Vol. 7 & 7A Hydrogeologic - Hydrologic Assessment and Conceptual Design

Comments by H. Keplin, Mar. '85

GROUND WATER FLOW CROSS SECTION B-B'		0-17
Hydrogeological Study Halton Region BURLINGTON LANDFILL SITE Continued Use		
Project 85-05		Gardiner Lee Associates Limited

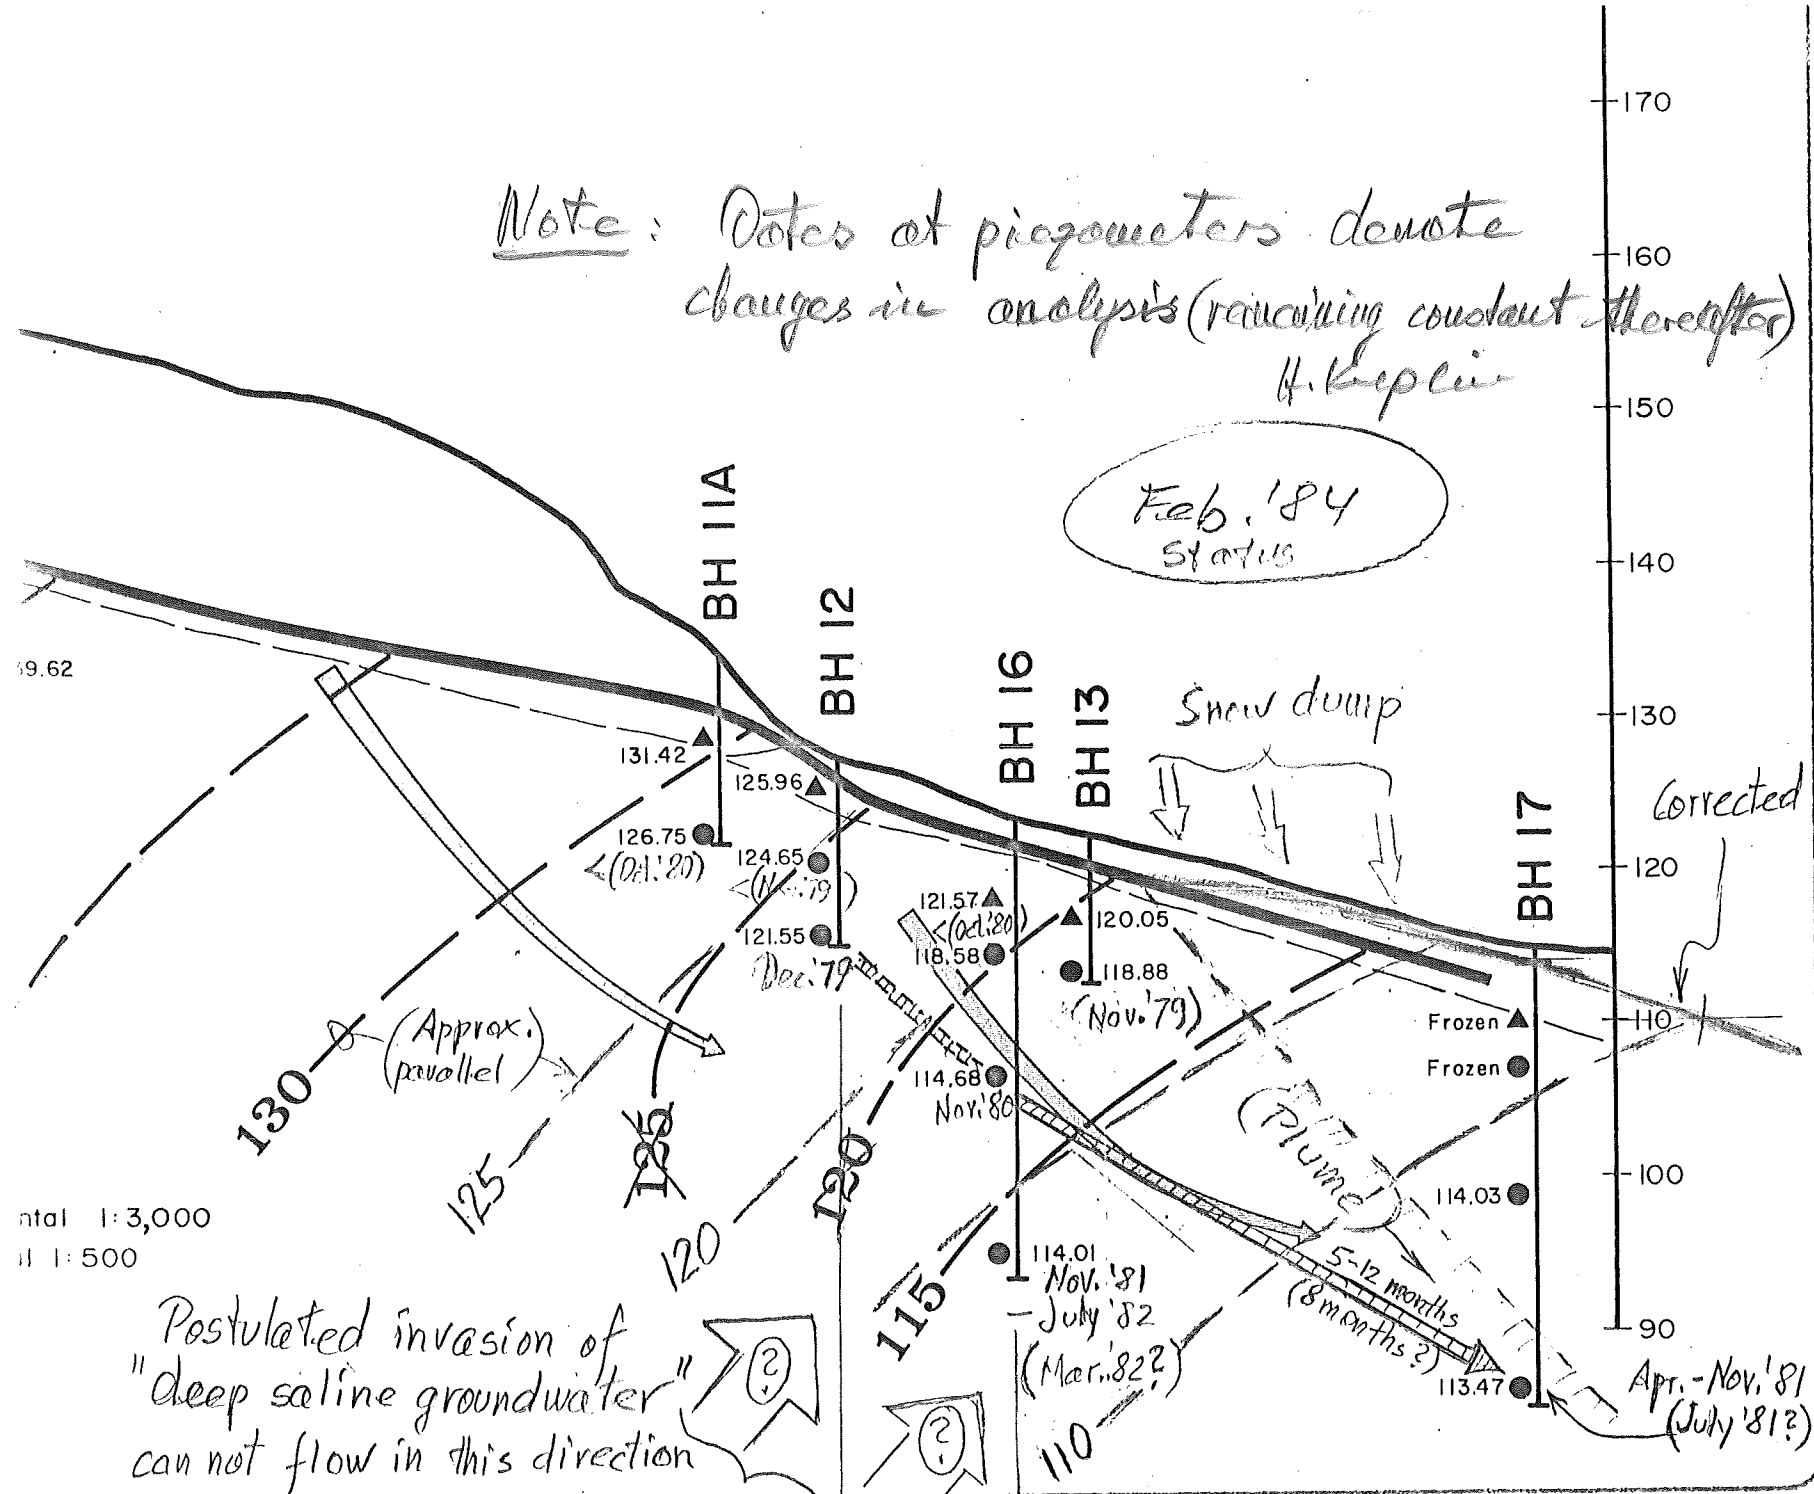
- NOTE: Dr. Clary observed that the leachate plume from Bayview extended to the deepest levels sampled, i.e., 0W-12 on NSP Rand described by Bayview, but this report does not mention 0W-12, see Fig. F3
- "Previous Work" came together at the 1984 EPA hearing (site expansion); there all experts rule. There if proponents agreed that no dump/landfill should have been started in the first place, considering the given hydrogeology. - This report (for a present) neglects to provide that necessary finding.
- "Previous Work" does not include the 1980 report by Dr. Clary "Hydrogeological Suitability of the NSP Landfill Site, Burlington, Ontario" See NOTE under (e) above and attached excerpts.

Note: Dates at piezometers denote changes in analysis (remaining constant thereafter)
H. Replin
